## ***Interactive comment on “Intercomparison of in situ water vapor balloon-borne measurements from Pico-SDLA H<sub>2</sub>O and FLASH-B in the tropical UTLS” by M. Ghysels et al.***

**M. Ghysels et al.**

Received and published: 10 February 2016

The authors wish to thank the anonymous referee #3 for his helpful comments. Below are the response to the referee #3 comments:

**Fig. 1.**

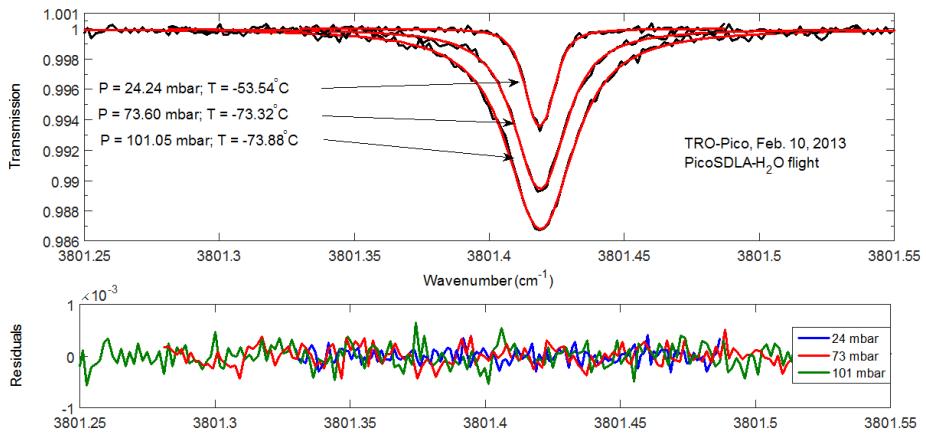
p 13699, l 20: Yes, on Figure 2 we show the transmission of the atmospheric spectra, in the text, line 21, we replaced atmospheric spectra by transmission of atmospheric spectra, like: "Figure 2 shows an example of the transmission of three atmospheric spectra of the H<sub>2</sub>O 202 $\leftarrow$ 101 line recorded during the February 10, 2013 flight in Bauru, at different altitudes in the lower stratosphere (24.24 hPa = 25.2 km; 73.60 hPa = 18.4 km; 101.05 hPa = 16.6 km). Then in the figure 2 caption: "Transmission of the atmospheric spectra of the 202 $\leftarrow$ 101 line of H<sub>2</sub>O from Pico-SDL A H<sub>2</sub>O measurements on February, 10, 2013 during the descent of the balloon. The top panel shows three experimental spectra (black line) and the results from fitting procedure(red line). These spectra were recorded at 25.2 km (24.24 mbar), 18.4 km (73.6 mbar) and 16.5 km (101.05 mbar) of altitude. The bottom panel shows the fit residuals for each spectrum."

The figure 2 has been updated (see below) following instructions and the figure caption has been corrected.

Fig. 3.

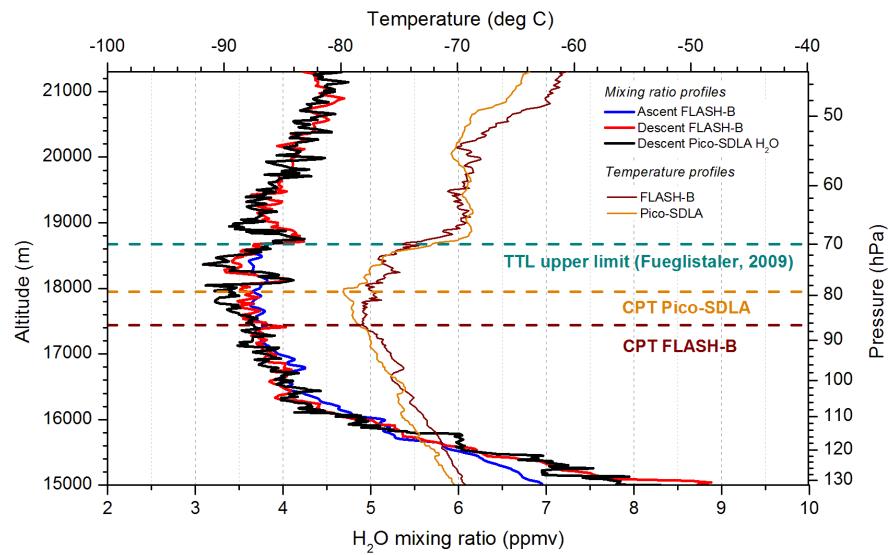
p 13709, l 15: On Figure 4, we removed the ascent data from and above 18 km because of outgassing contamination. However, this structure is visible in the dataset. This is the meaning of the sentence : "Because of a small amount of outgassing, the profile above 17.7 km cannot be considered. Nevertheless, structures are visible." p 13709, l 16-17. We added one paragraph to correct the information missing about the structure at 17.8 and 18.1 km on FLASH ascent profile which were not mentioned before: "The structure at 18 km was captured by FLASH-B at the ascent and at the descent. The ascent profile of FLASH-B shows only one structure at 18 km whereas the descent profile shows two structures at 17.8 and 18.1 km of 280 and 300 m thickness respectively."

p 13709, l 16-17: We refer to the ascent profile of FLASH. We mentioned again that the ascent profile has been cut from 18 km because we talk about a structure at 18 km that we do not show on the figure. It is a reminder. Outgassing contamination and geographical/temporal shift have a different impact on the water vapor profile. The difference in spatial structures between FLASH and Pico-SDLA profiles can be attributed to geographical/temporal shift. These differences are localized. Outgassing effects induce a constant increase of the background concentration with the altitude over the entire profile. Discriminating these 2 effects is easy.
